California Regional Water Quality Control Board

April 29, 2010

**SUBJECT: NOTICE OF VIOLATION AND REVIEW AND COMMENT ON
"TECHNICAL MEMO RE: CORRECTIVE ACTION PLAN" AND
"CORRECTIVE PLAN SUPPLEMENT" FOR SIGNET ARMORLITE
1001 ARMORLITE DRIVE, SAN MARCOS, CALIFORNIA**

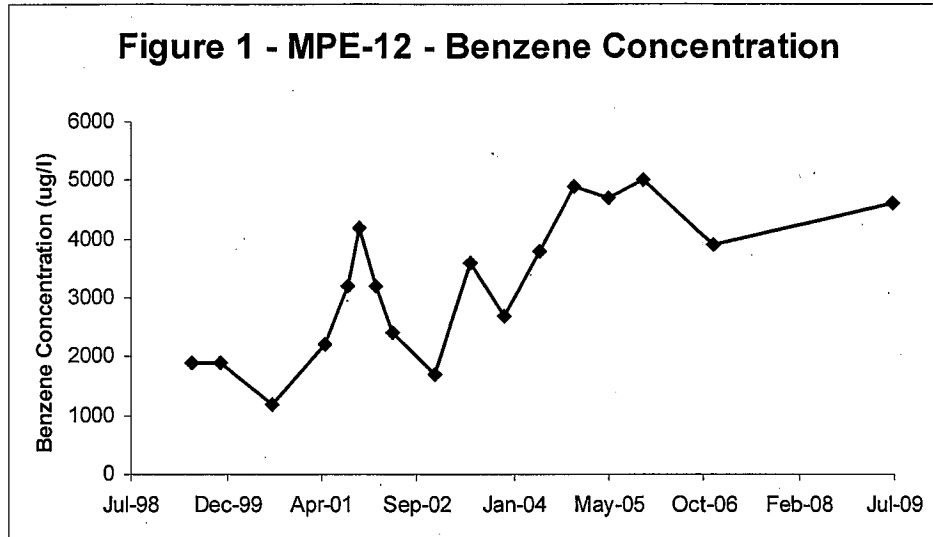
Not all the data supports this contention. As shown on Figure 1, groundwater samples collected from well MPE-12 have shown increasing benzene concentrations since the termination of the active groundwater remediation.

The CAP must demonstrate plume stability. The CAP Supplement states that the horizontal extent of the dissolved benzene plume is stable and that benzene concentrations are generally stable or reducing. To support this contention, data should be presented that clearly illustrates that all COC concentrations are stable or reducing *since the termination of active groundwater remediation*.
